ADDENDUM NO. 7

Reference: Northern Utah Interagency Fire Dispatch Center
DNR – Draper, Utah
Project No.10013500

Northern Utah Interagency Fire Dispatch Center

ADDENDUM NO. # 07

SHEET TITLE: **UTILITY PLAN**
SHEET NUMBER: **CE-107**

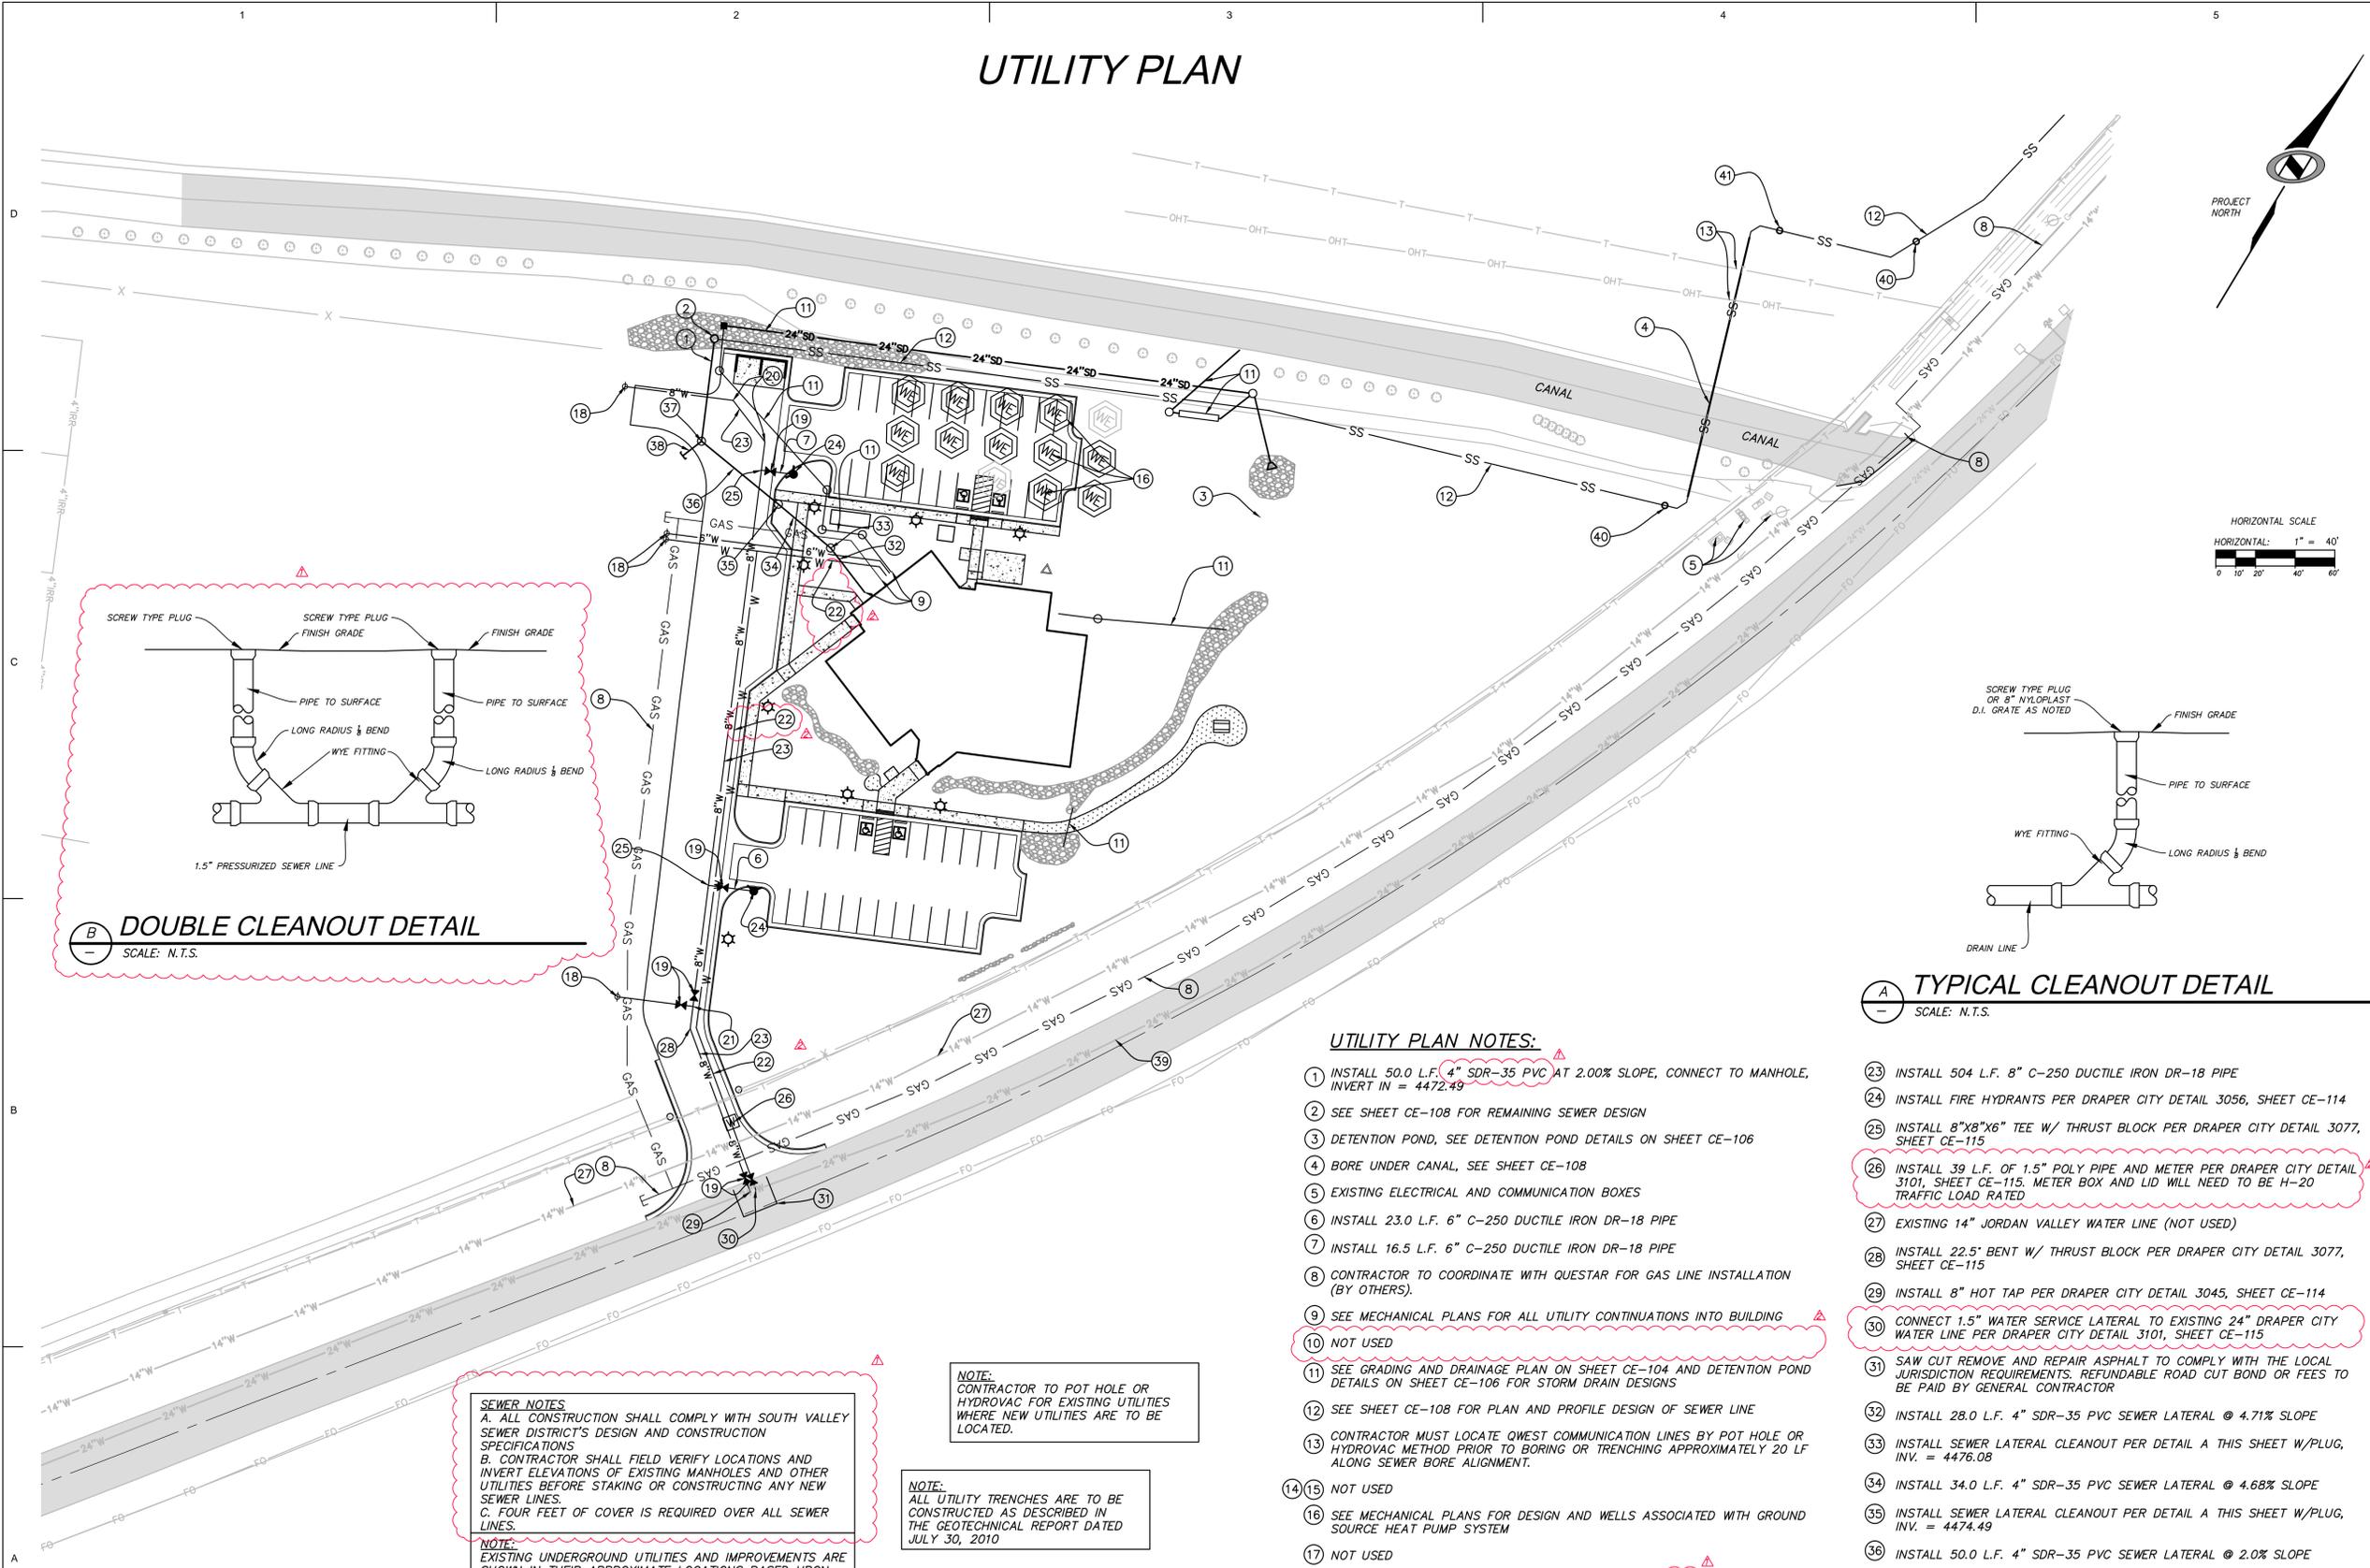
Item #1 - CE-107 - Sheet replacement

Replace sheet CE-107 that was included in Addendum #06 with the revised sheet CE-107 attached to this final addendum.

ES101

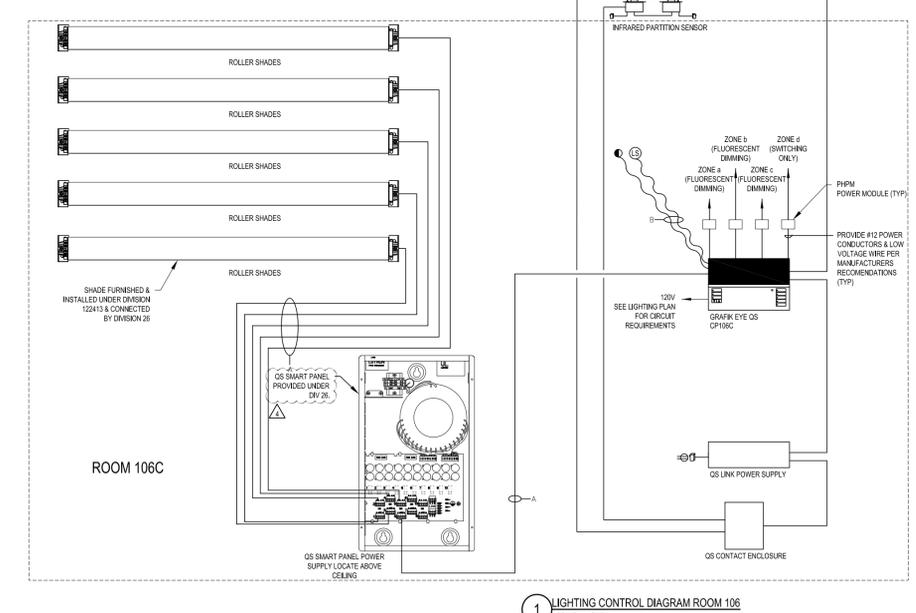
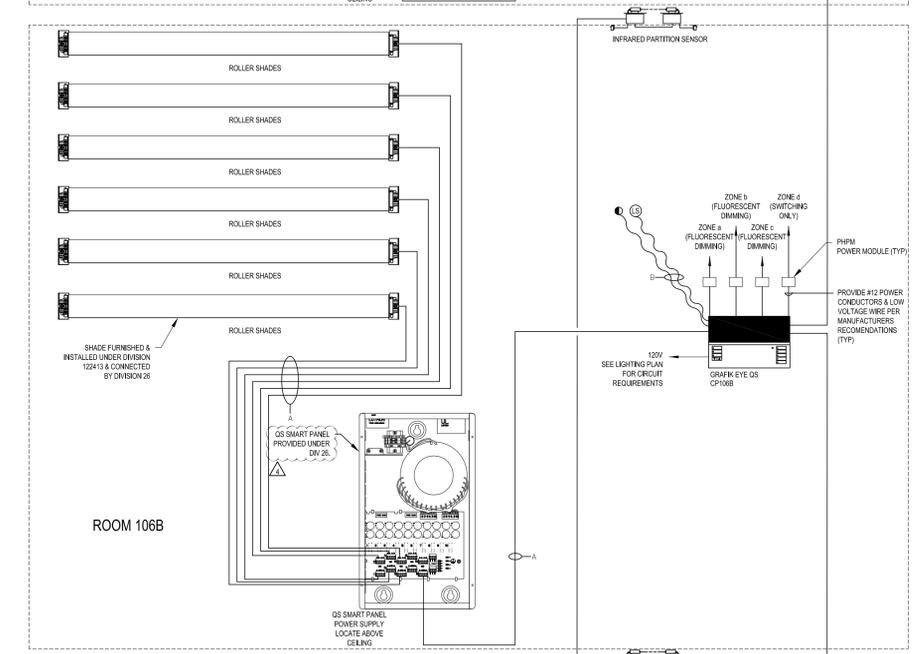
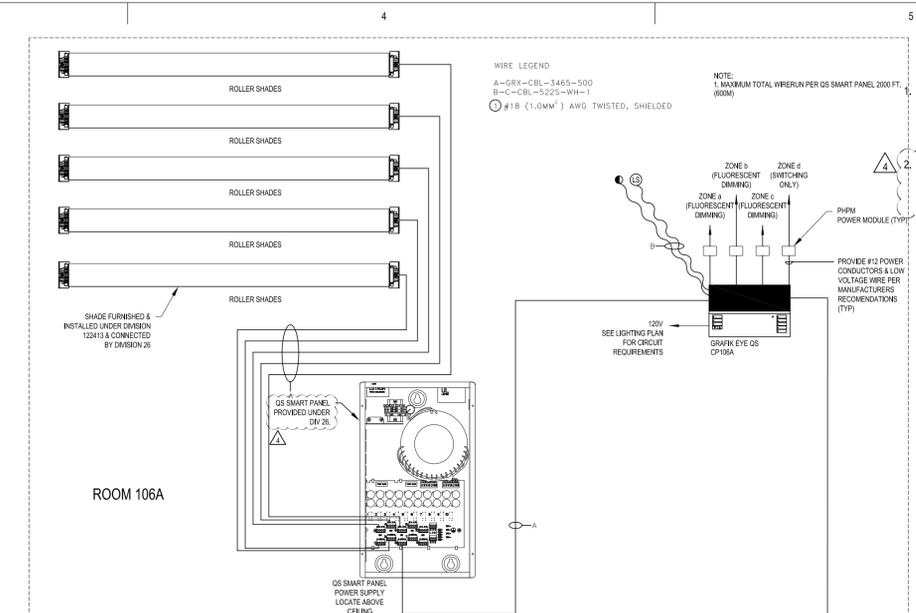
SHEET ES101: Site Electrical

1. Coordinate location of temporary power to site with RMP. All costs for temporary power are contractor’s responsibility. Refer to ES101 for clouded changes.
